TRANS/WP.29/576
15 July 1997

Working Party on the Construction of Vehicles

DRAFT SUPPLEMENT 1 TO THE 03 SERIES OF AMENDMENTS
TO REGULATION No. 36

(Public service vehicles)

"5.7.4. Access to escape hatches

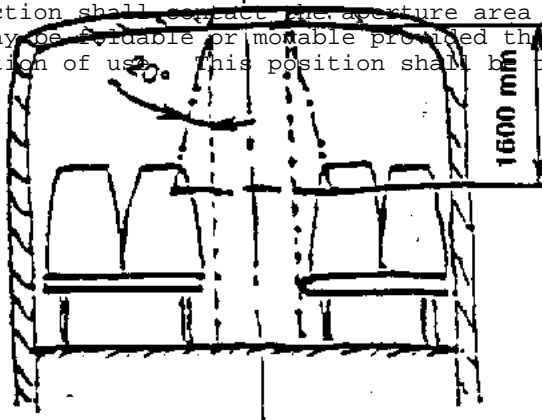
- 5.7.4.1. Except in the case of Class I vehicles, at least one escape hatch shall be located such that a four-sided truncated pyramid having a side angle of 20° and a height of 1,600 mm touches part of a seat or equivalent support. The axis of the pyramid shall be vertical and its smaller section shall contact the aperture area of the escape hatch. Supports may be foldable or movable provided they can be locked in their position of use. This position shall be taken for verification.

- 5.7.4.2. When the structural thickness of the roof is more than 150 mm, the smaller section of the pyramid shall contact the aperture area of the escape hatch at the level of the outside surface of the roof."

Figure A

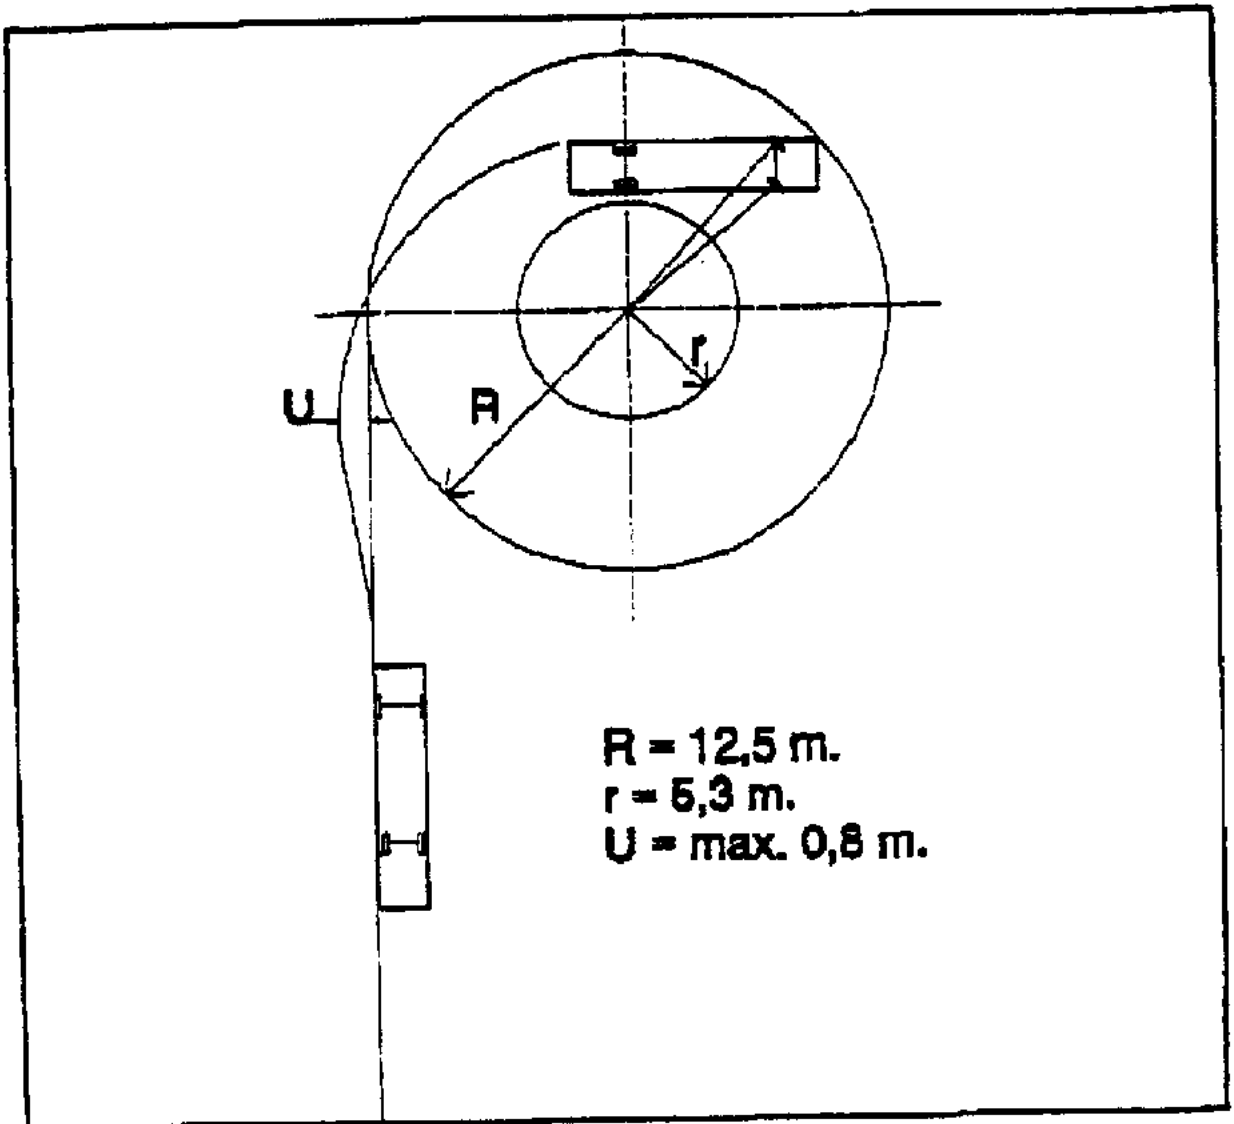
"5.10.1. The vehicle shall be able to manoeuvre on either lock inside a circle of 12.5 m radius without any of its outermost points projecting outside the circumference of the circle.

5.10.2. When the outermost points of the vehicle are moving on either lock on a circle of 12.5 m radius the vehicle shall be able to move within the limits of a circular track 7.2 m wide (see annex 4, figure A/B)."

"5.10.3. With the vehicle stationary, a vertical plane tangential to the side of the vehicle and facing outwards from the circle shall be established by marking a line on the ground. In the case of an articulated vehicle the two rigid portions shall be aligned with the plane. When the vehicle moves from a straight line approach into the circular area described in paragraphs 5.10.1. and 5.10.2. above, no part of it shall move outside of this vertical plane by

more than 0.8 m (see annex 4. figure A) in the case of a rigid vehicle, or by more than 1.2 m (see annex 4, figure B) in the case of an articulated vehicle."

Annex 4, figures A and B, replace by the following figures (figure C being deleted):
